PLUG & ABANDONMENT PROCEDURE

Ruddock #7A

CONDITIONS OF APPROVAL FOR PERMANENT ABANDONMENT

Operator Energen Resources Well Name Ruddock #7A

Proposed P & A

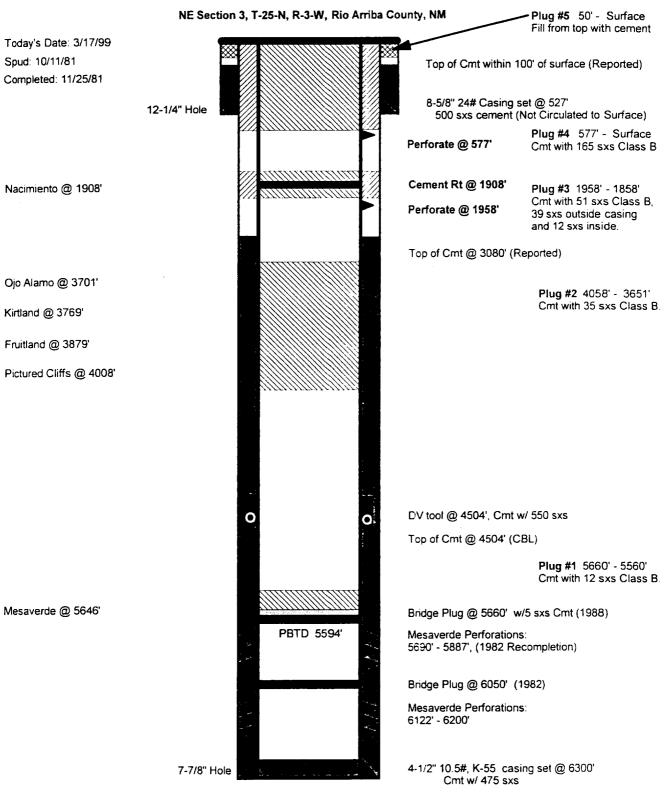
Plug #2 - Drill logs from adjacent wells show top of the Ojo Alamo at about 3450' Plug #2 needs to be increased to cover from 4058' to 3400'.

Plug #3 - Drill logs show that the top of the Nacimiento is about 1870'. Plug #3 needs to be moved to covered 1920' to 1820'.
